Harrell Stream and Wetland Mitigation Site

Monitoring Year 2 (2021)

NCDMS Project No. 100005

Subject: Draft Monitoring Year 2 (MY2) Report for the
Harrell Stream and Wetland Site
Little Tennessee River Basin – CU# 06010203– Jackson County
DMS Project ID No. 100005
Contract # 007006

MY2 CCPV
 Harrell Mitigation Site
 Jackson County, NC
 October 2021

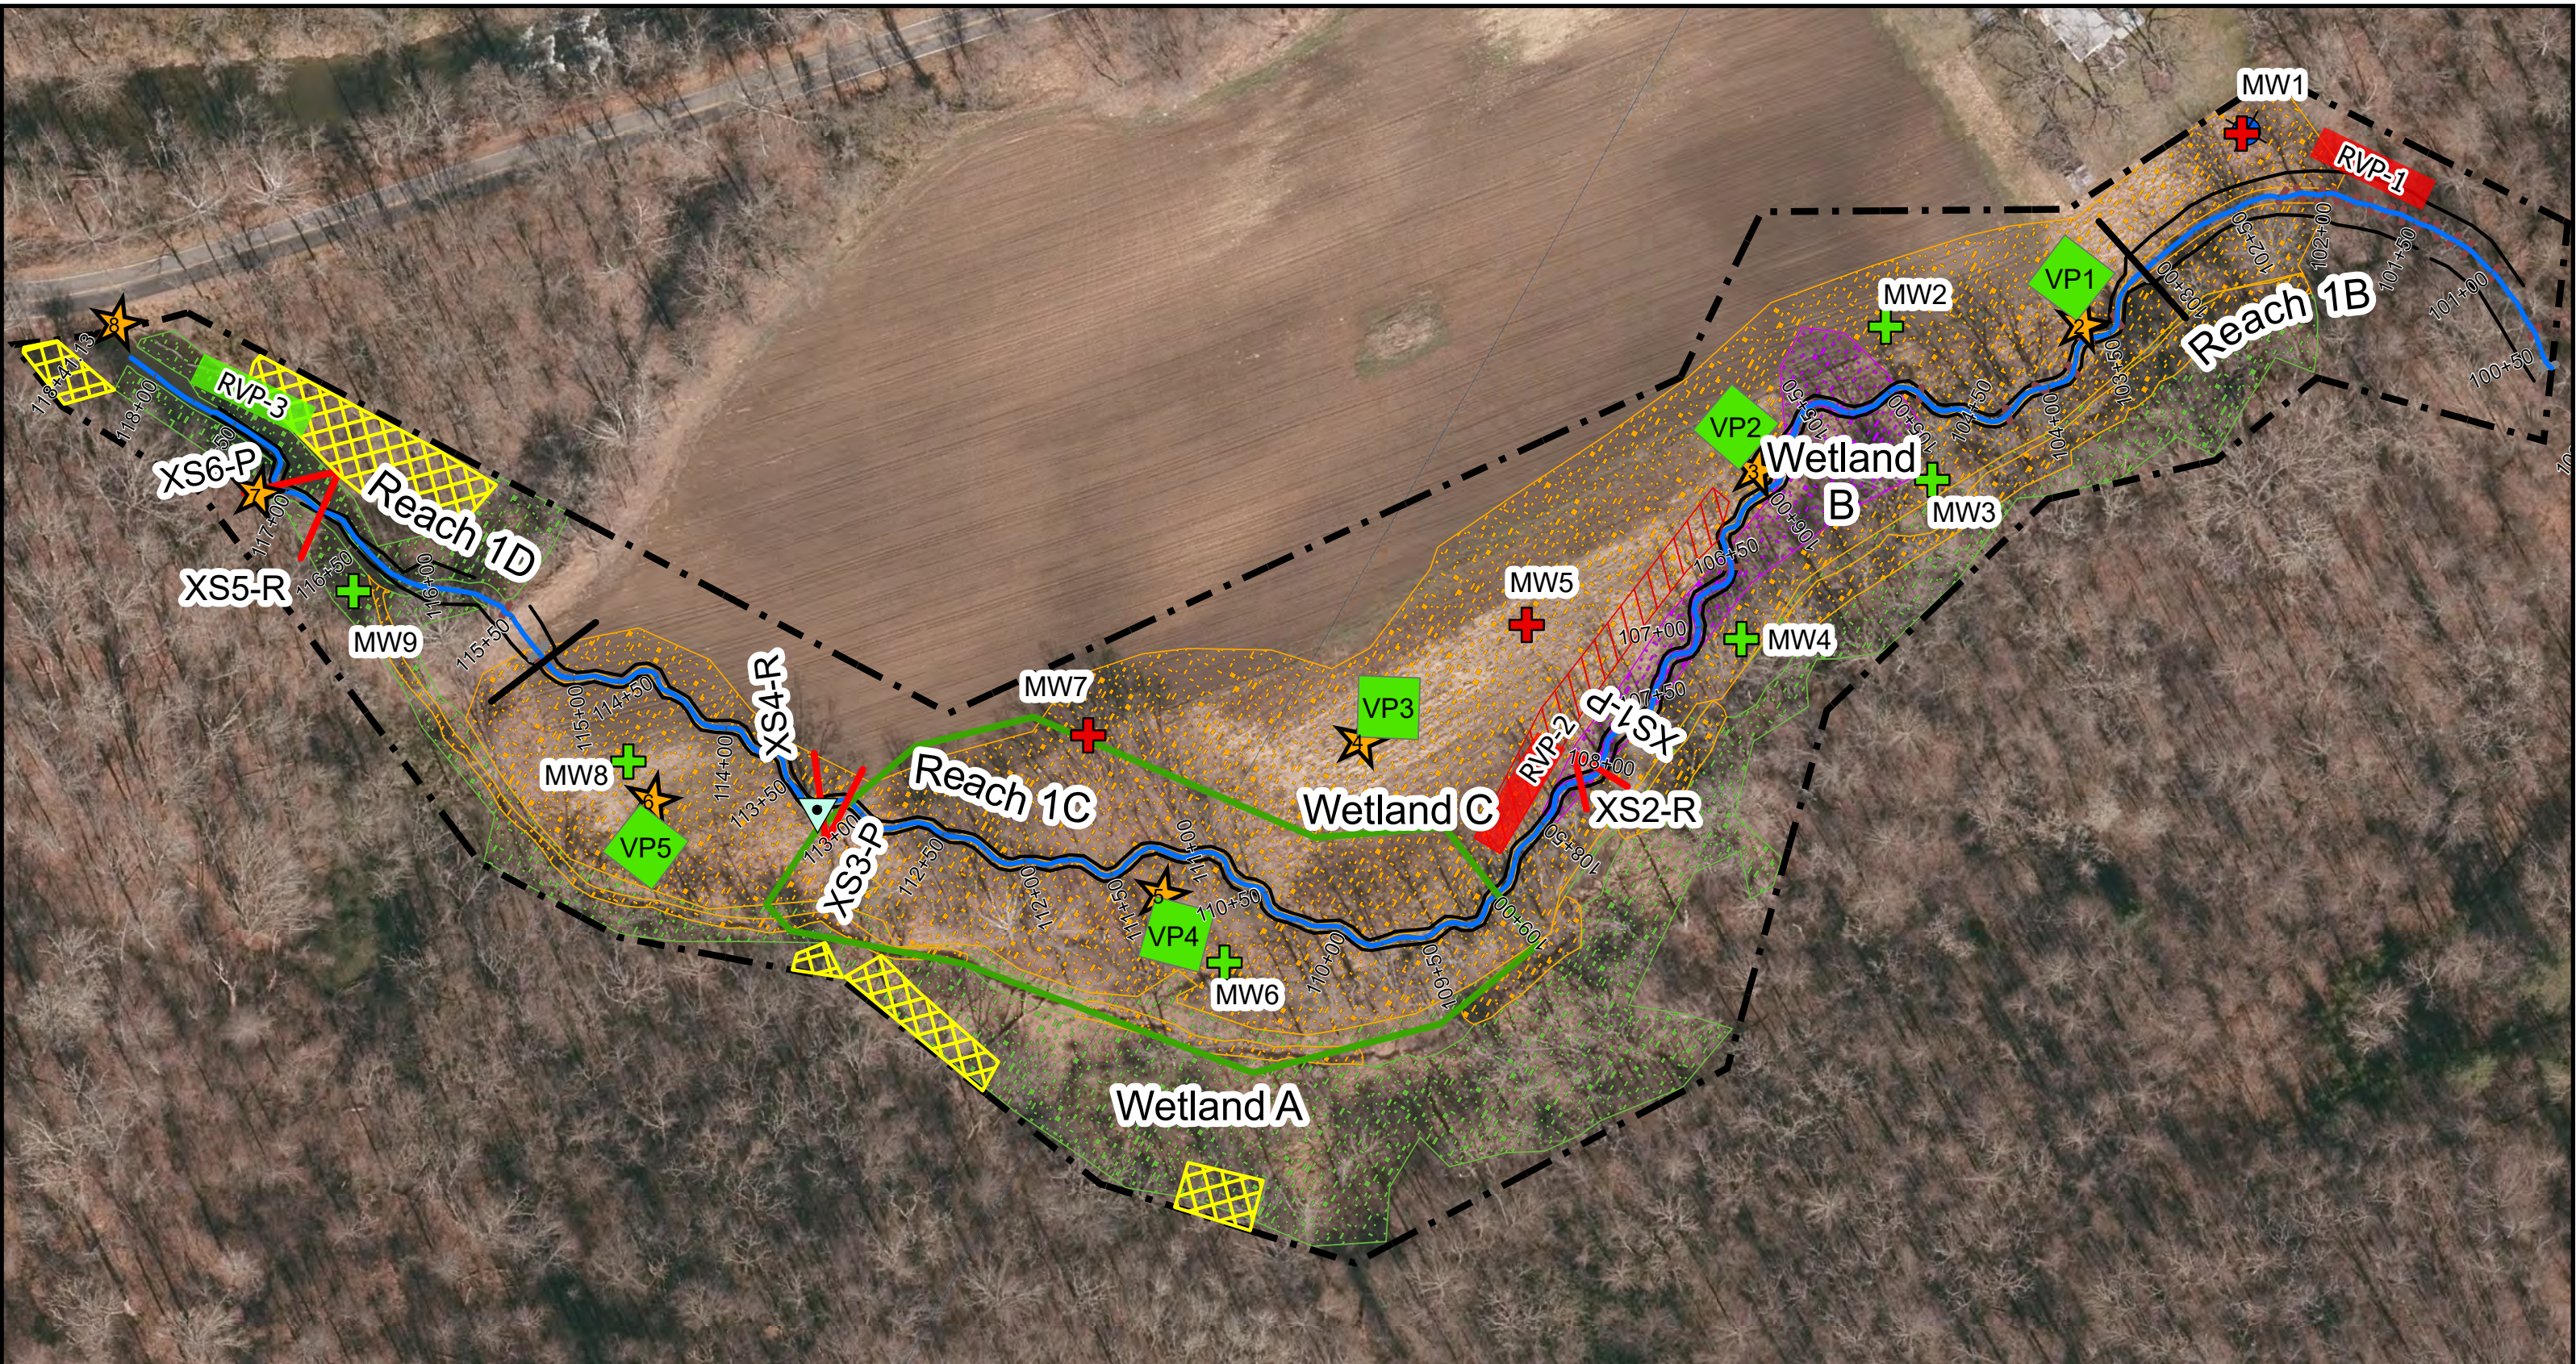
CCPV Maps: Please include a legend item noting that vegetation plots (fixed or random) shown in “Red” are not currently meeting the interim vegetation success criteria. The legend should also show “Green” vegetation plots as meeting the interim vegetation success criteria. **Legend corrected.**
